Approved Septic System Plan
Howard County Health Department
Signature: [Signature] Date: 11/23/2023

3085 WOODBINE ROAD
WOODBINE, MD 21797
PARCEL 223, MAP 13, 6.78 ACRES
PLAT 11780, WARFIELD RIDGE
ONSITE SEWAGE DISPOSAL DESIGN PLAN

ONSITE SEWAGE DISPOSAL DESIGN PLAN

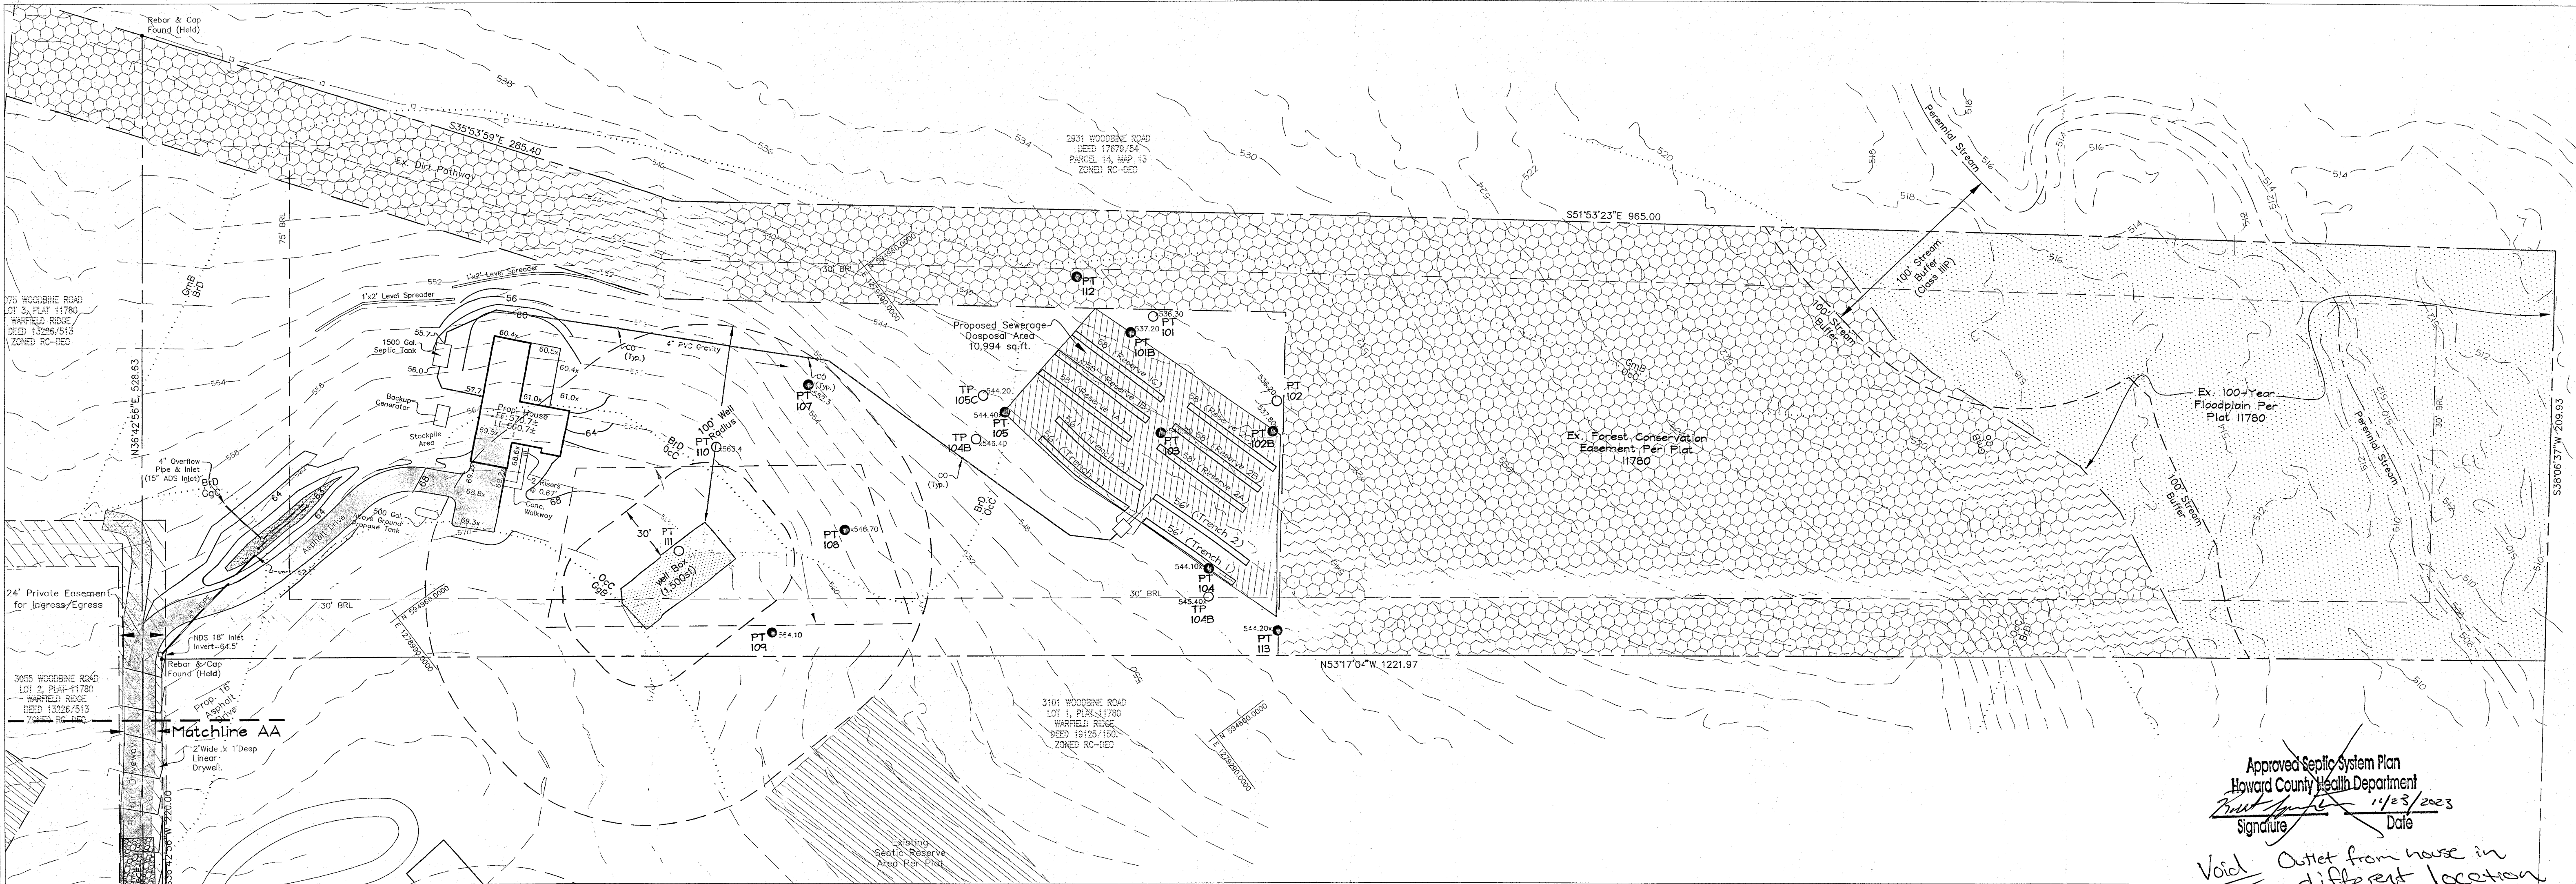
Informed Jim over
phone he could make Initial
Trench 1 $\frac{1}{3}$ 2 ^(rightside) connect to
Reserve Trench 2A $\frac{1}{3}$ 2B
to be the initial system
redlined. Specs are very
similar for all systems.
He would just keep/continue Initial
specs for Reserve Trench
2A $\frac{1}{3}$ 2B and shorten them
by 2' to match initial trench
lengths. Told him to send PDF
to you and me since I will
be in training. He will try to
send tomorrow.

Void Outlet from house in different location
